SERVICE BULLETIN

SB No. 017

T67A AFT TAILPLANE LOCATION BRACKETS

VIEW ON PORT BRACKETS

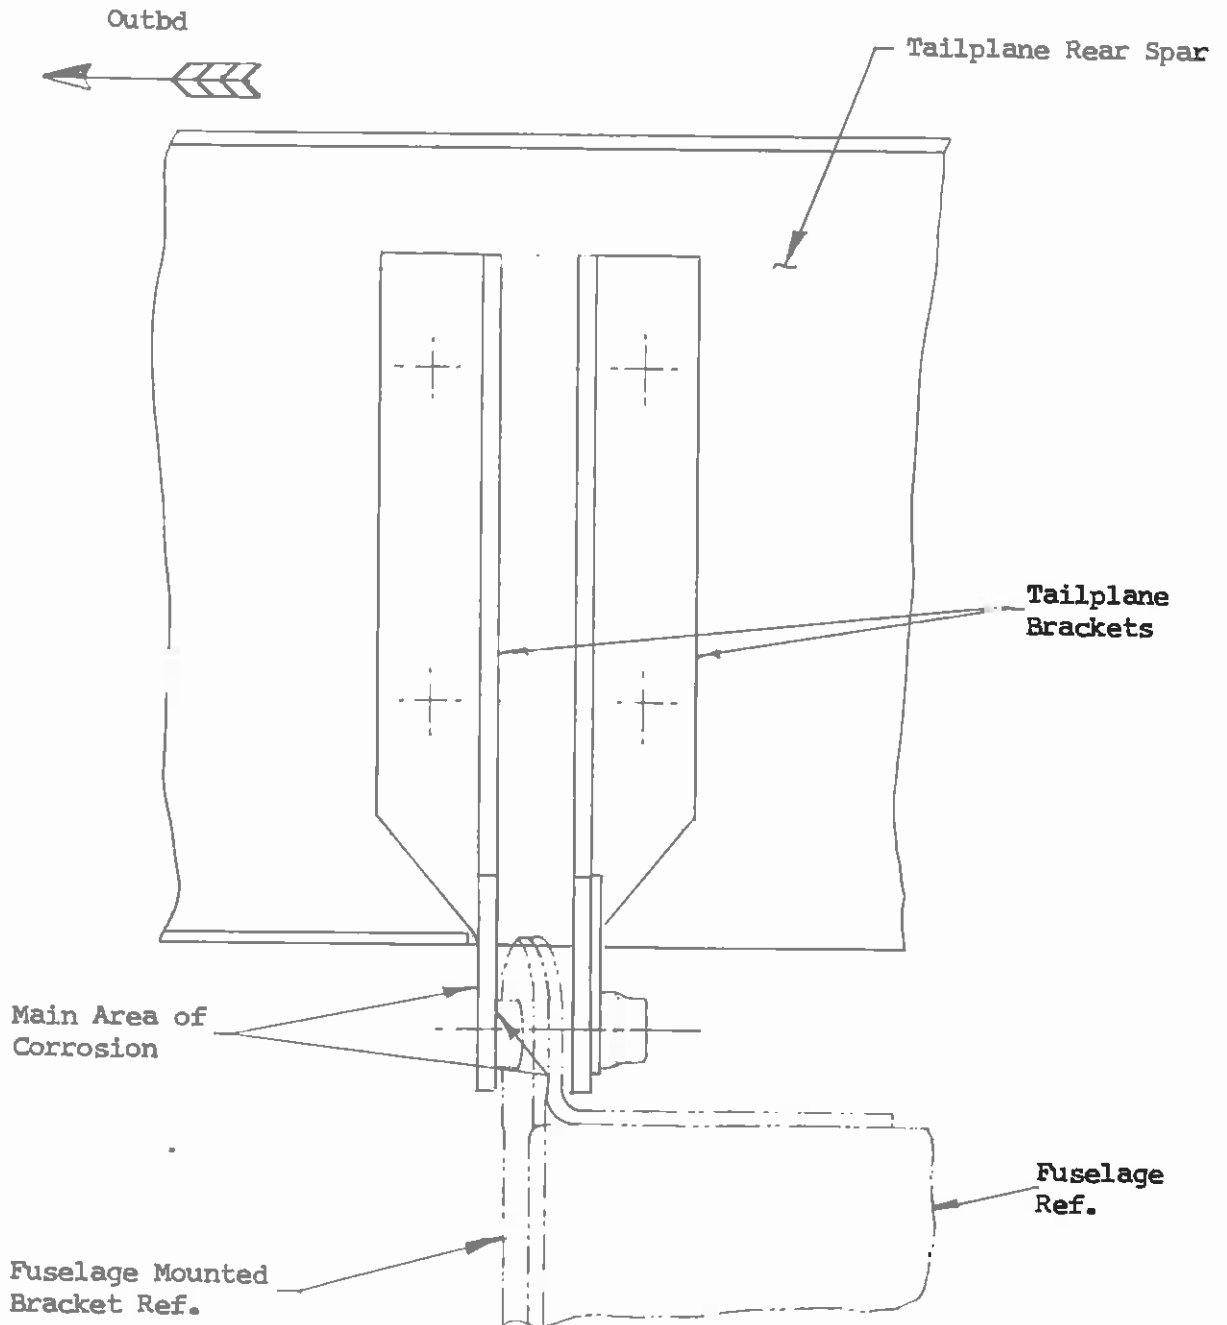
Partially remove tailplane and inspect for corrosion, especially on the inside of the outer brackets. Ref. Fig. 1 on page 2.

3.2.1 If no corrosion found reassemble tailplane.

3.2.2 If corrosion found change brackets refer Modification Bulletin M255.
